SUMMARY COMMITTEE

Thursday, November 7, 2013 - 11:00 am

SUMMARY INDEX
CITY OF SANTA FE
SUMMARY COMMITTEE
November 7, 2013

Photographs

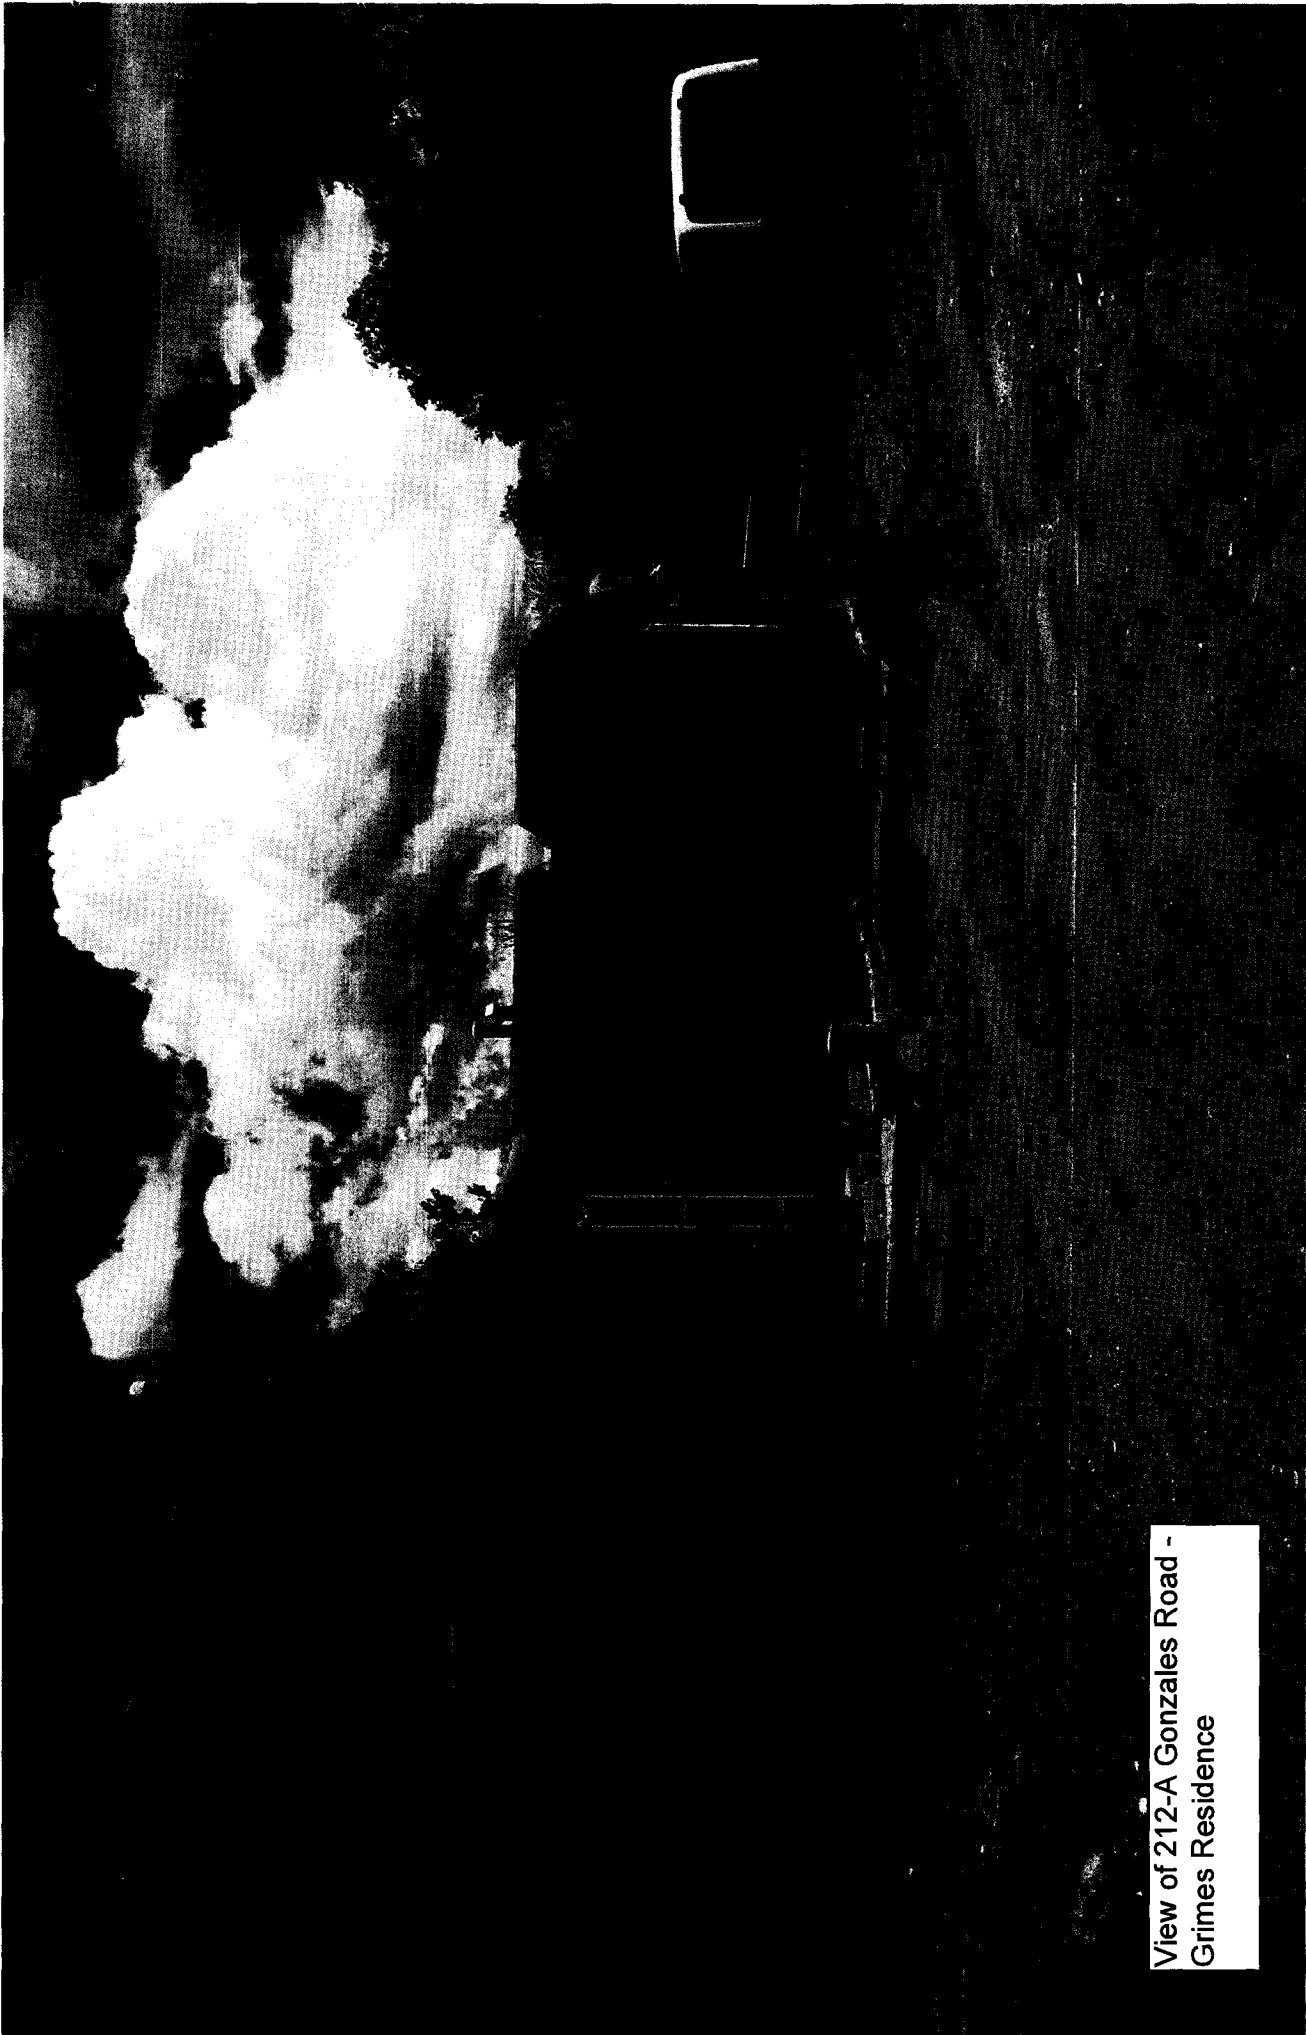
Commissioner Padilla said, in the first photo in Exhibit D that shows the existing residences, it appears to him that there is a fence or fence line to the east of the existing residence, which doesn't show up in the survey in the packet, which would be the final plat. He asks if that shows a proposed lot.
